ADDENDUM NO. 4:

Date: February 13, 2026
 Project: Verbena HS Gym
 DCM# 2025629
 WSM# 25-032

Owner: Chilton County Board of Education
 Architect: Ward Scott Morris Architecture, Inc.

PROJECT: Verbena HS Gym	ENG #2559 ARCH #25-032 DCM #2025629	DATE: February 13, 2026
-----------------------------------	---	-----------------------------------

BID DOCUMENTS		
DATE: 01/08/26 PROJ NO: 25-032		
REVISIONS		
#	DESC	DATE
1	ADD 004	02/13/26
SANITARY PLAN		
P101

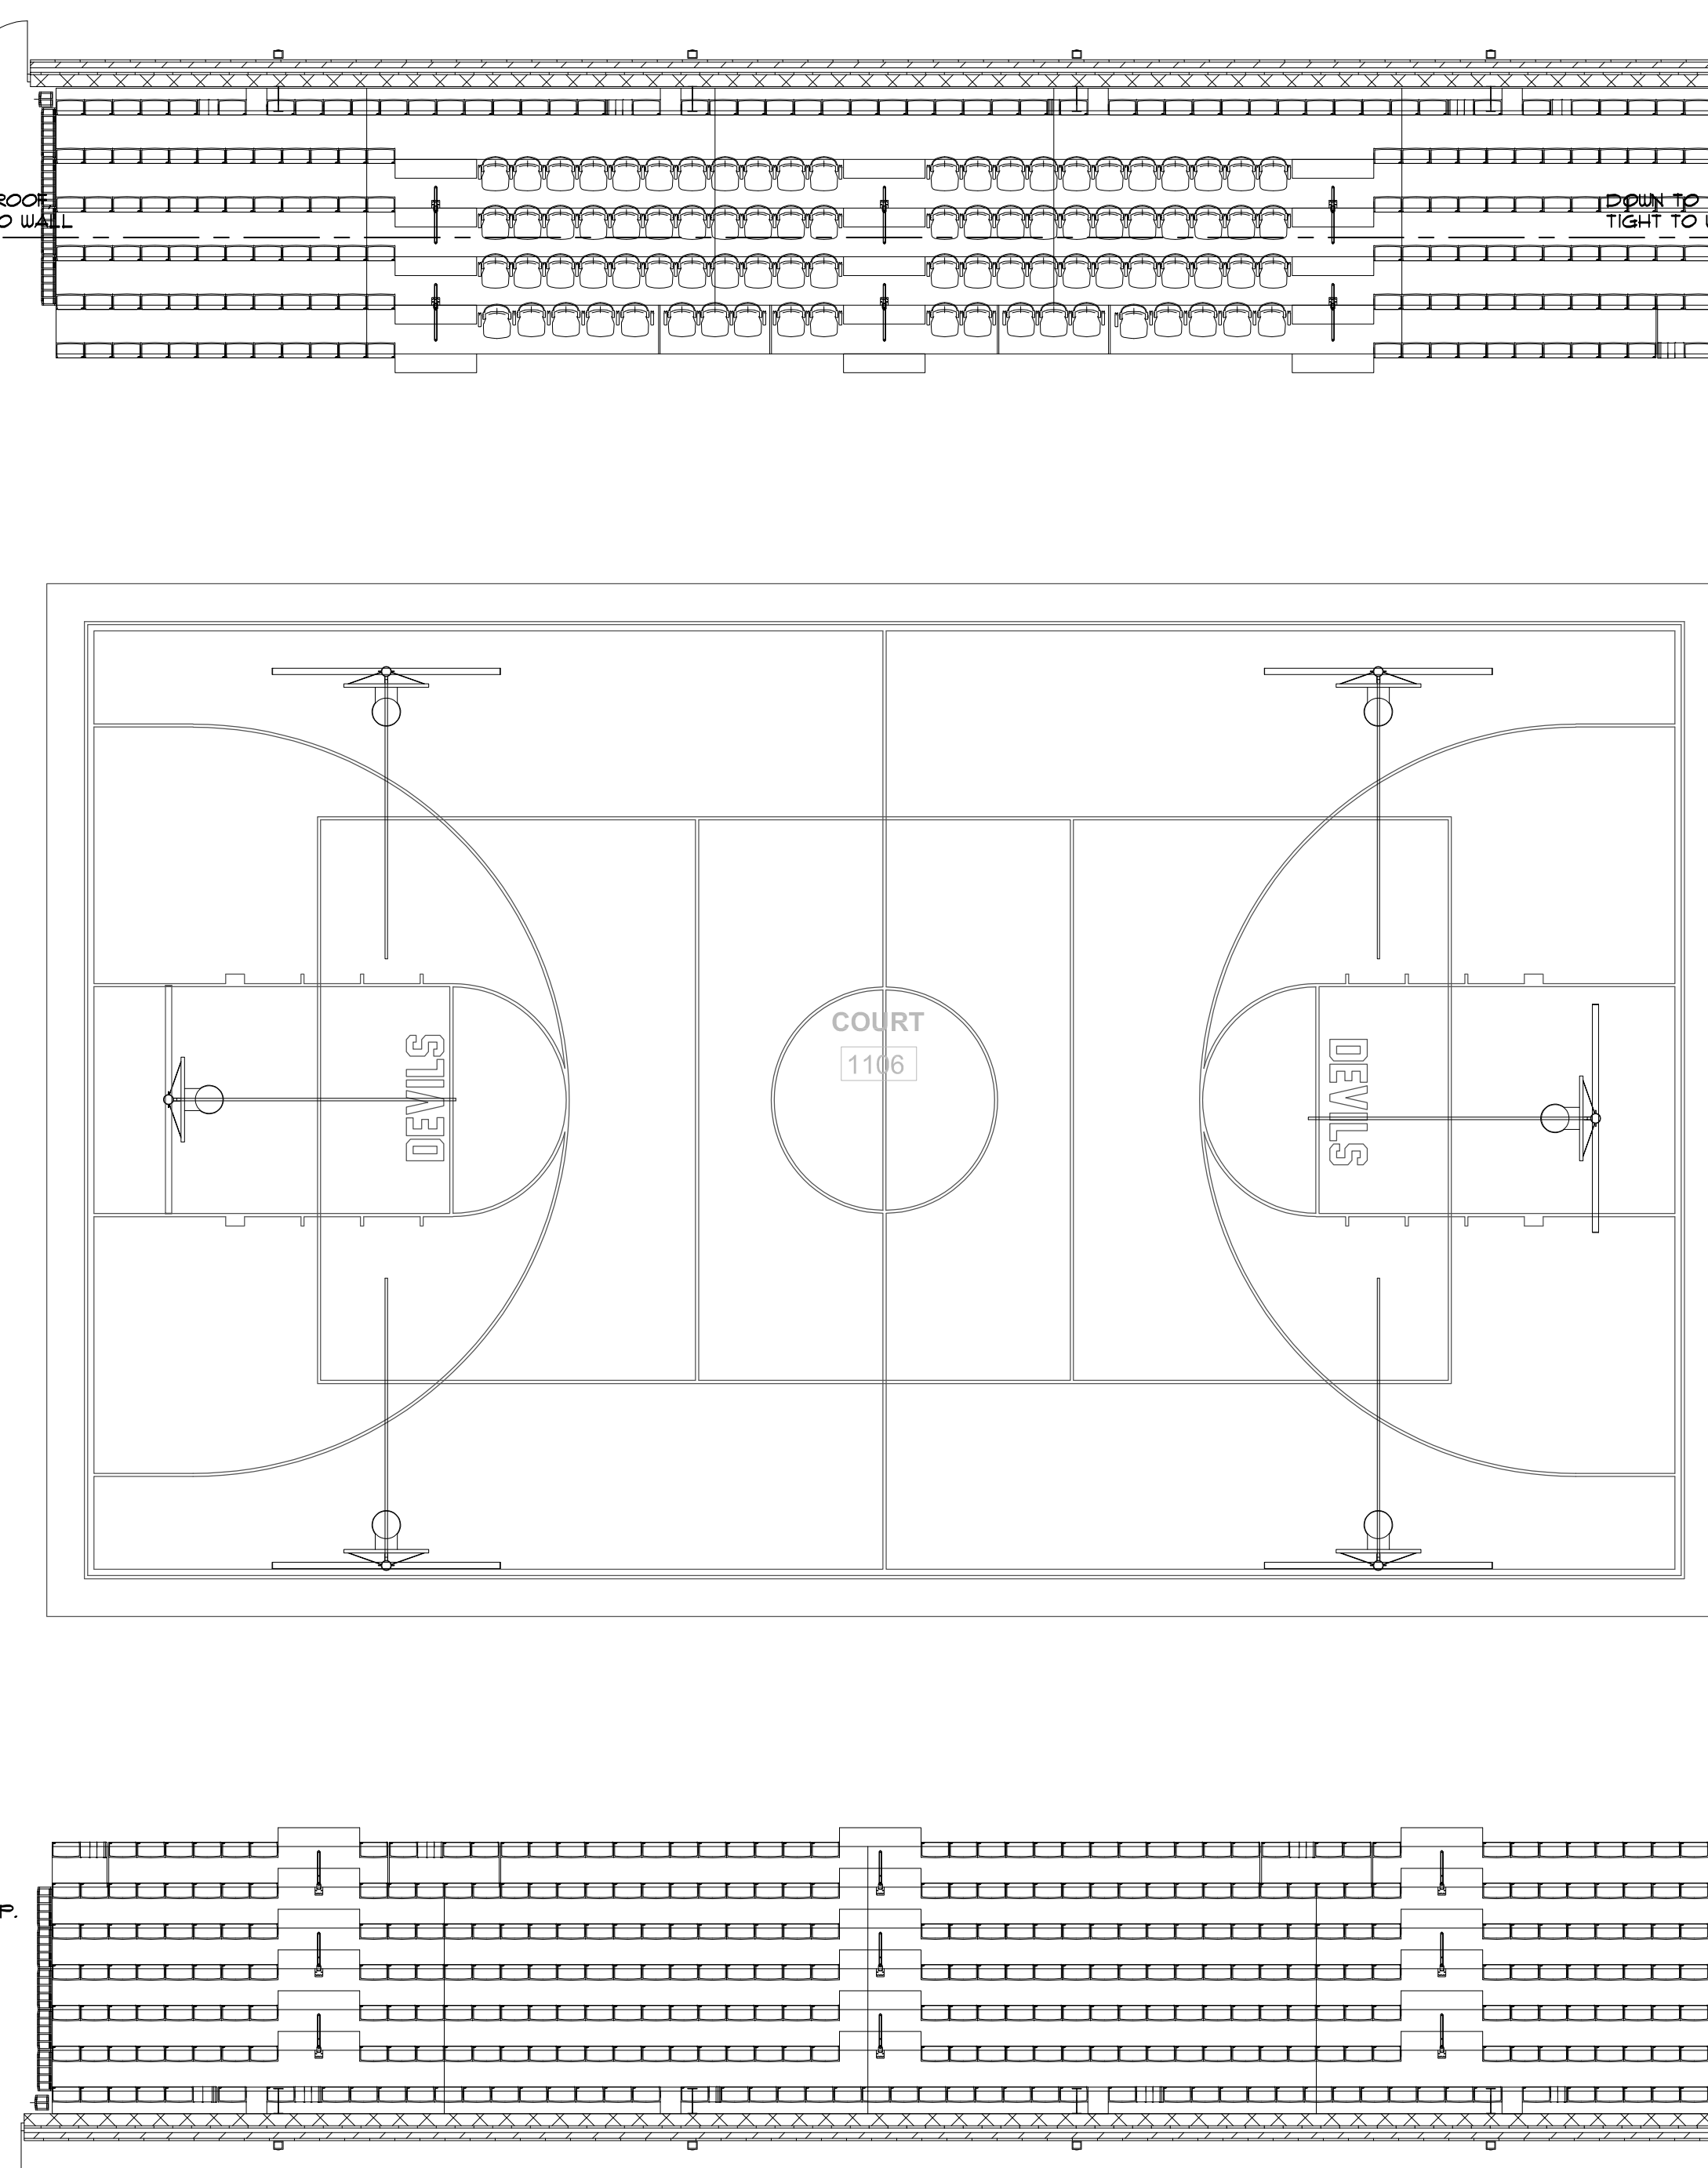
1. Sheet P001: P-17 is recirculating pump for domestic water.
2. Sheet P101: Delete floor drain in former fire pump room.
3. Sheet P201: Delete pressure boosting pump. New water service to area provides 75 PSI.
4. Sheet P201: Relocate water service to Riser 1109

E002

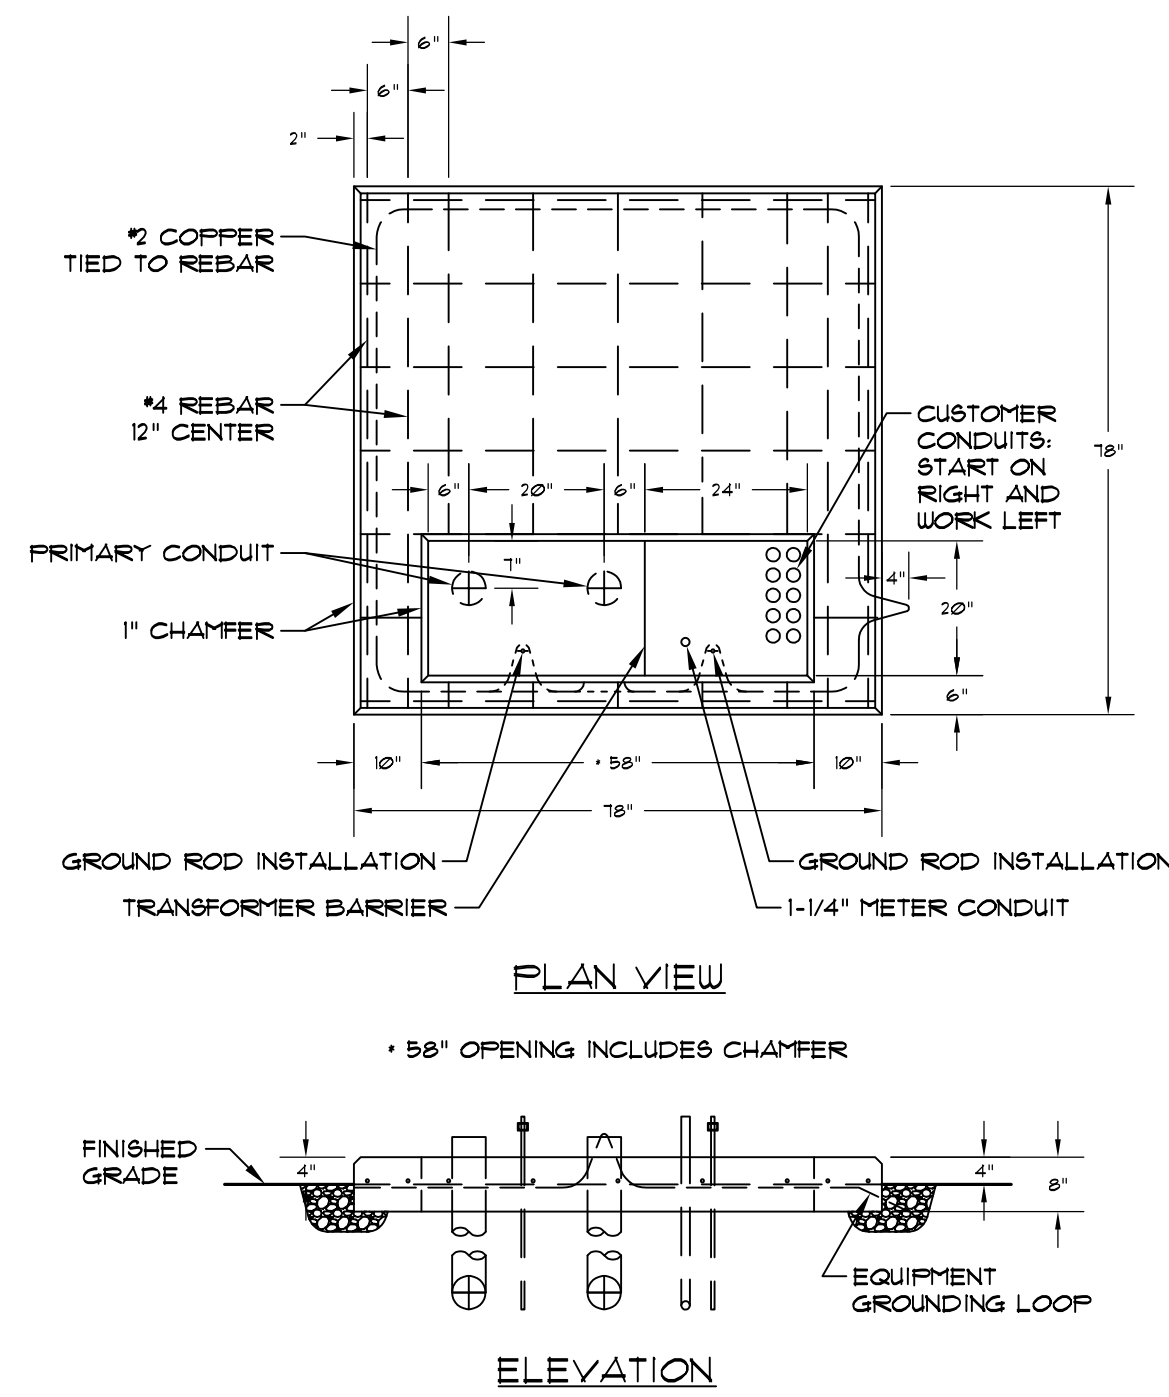
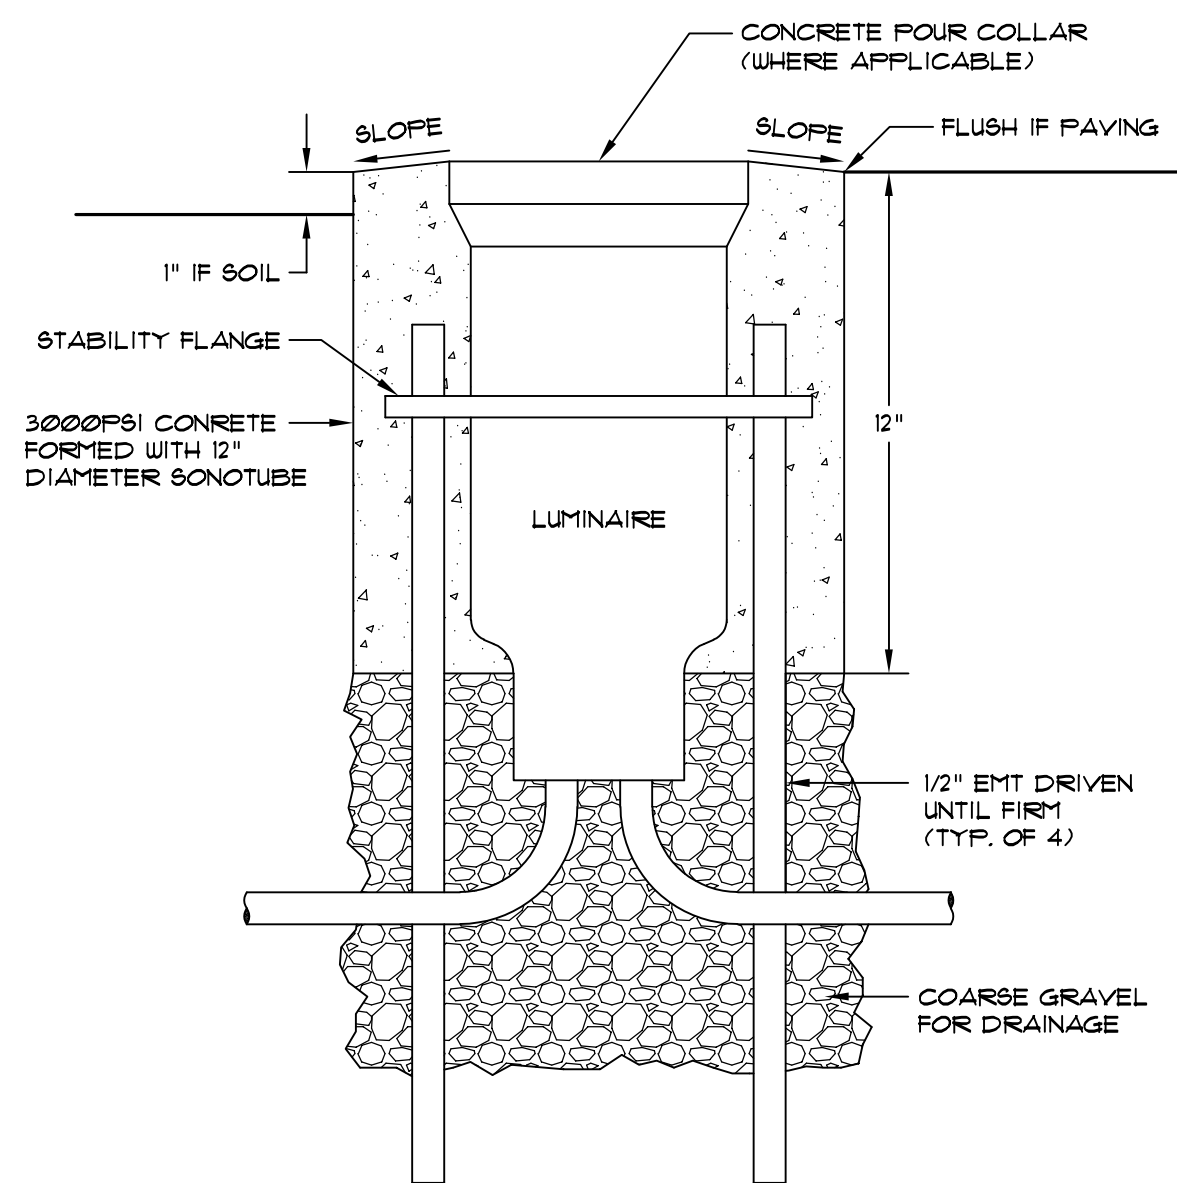
1. Sheet E001, Gymnasium Riser Diagram: Service to fire pump controller removed
2. Sheet E002:
 - a. Panel 'A' Schedule: Breakers serving 'Pressure Booster' and 'Jockey Pump' removed

- b. Panel 'B' Schedule: Panel revised to 84 space
3. Sheet E101:
 - a. Gymnasium – Power Wiring Plan:
 - i. Service to fire pump controller removed
 - ii. Storage 1105: CBB 1 relocated to 'Elec 1104'
